The Republic, Mayfield Manchester
Planning Addendum Report
0197_MAY-MCO-M01-XXXX-RP-A-090080
Rev: P03
Ref: A283-10.01-148
November 2024

1.0 Planning Addendum

1.1 Introduction

2.14 West Elevation

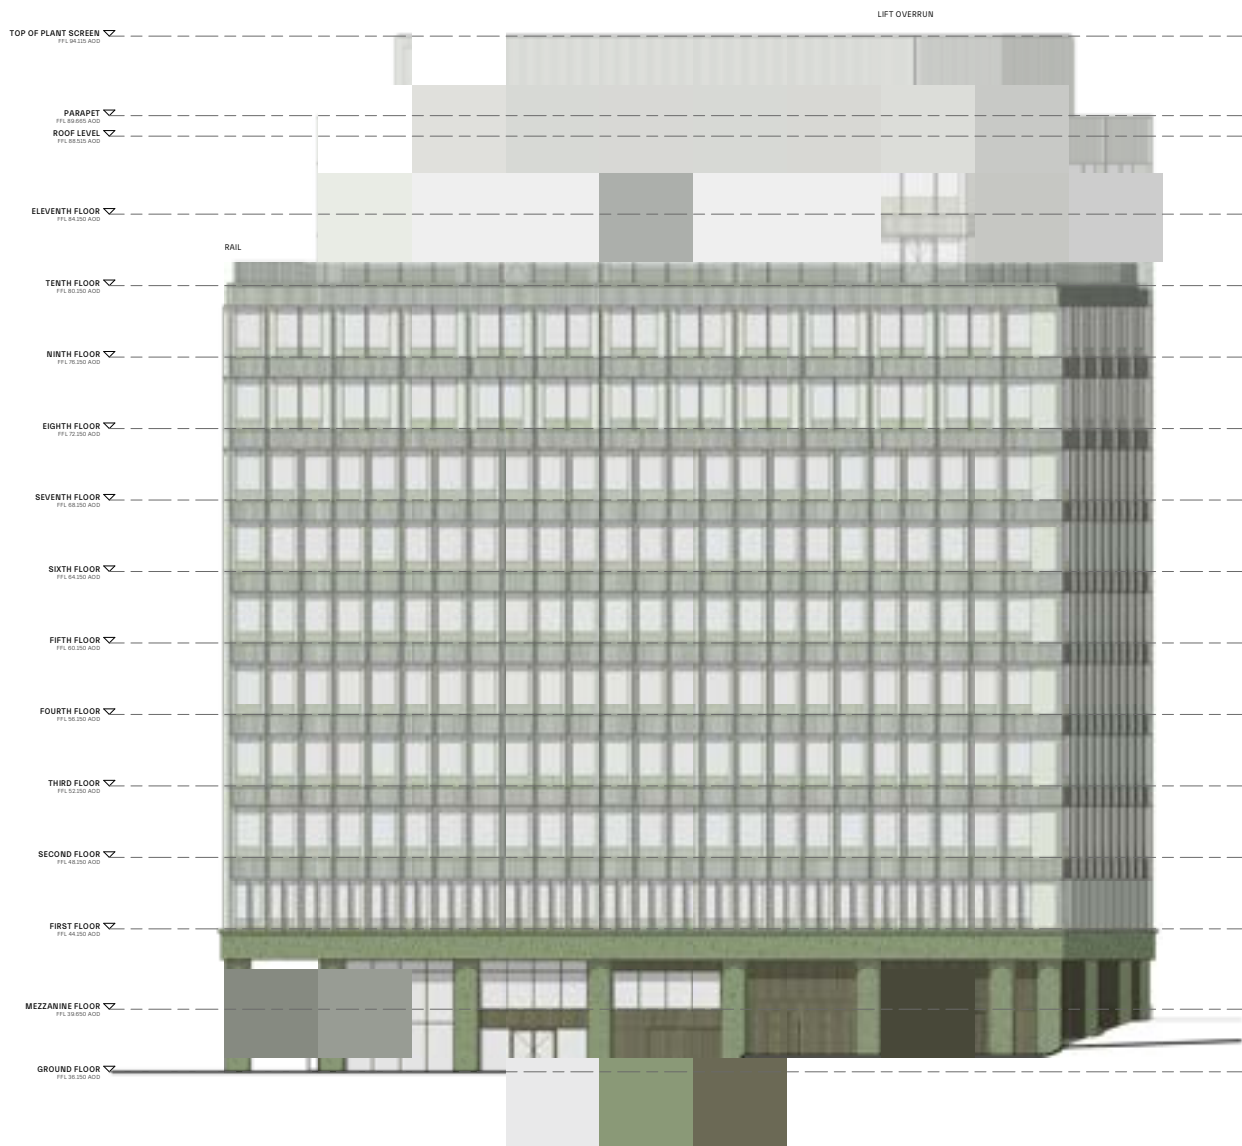
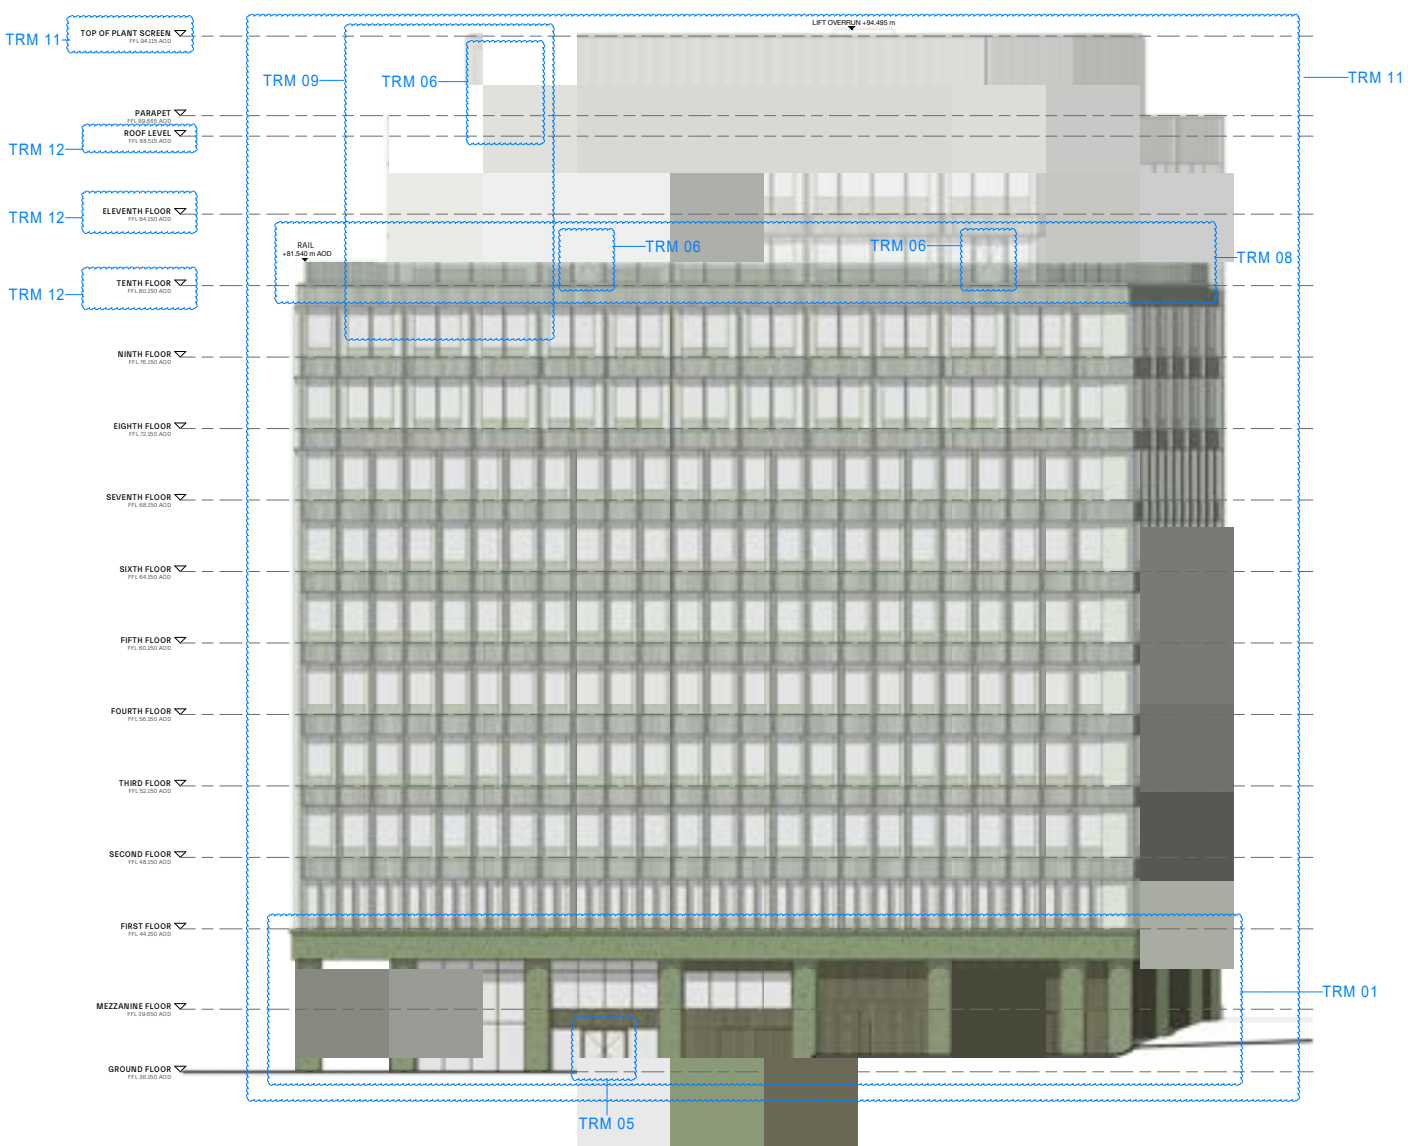
- + TRM 01 - Structural Grid
- + TRM 05 - Ground Floor Entrance
- + TRM 06 - External Doors
- + TRM 08- External Amenity Spaces
- + TRM 09 - Massing to North
- + TRM 11 - Facade Development
- + TRM 12 - FFL
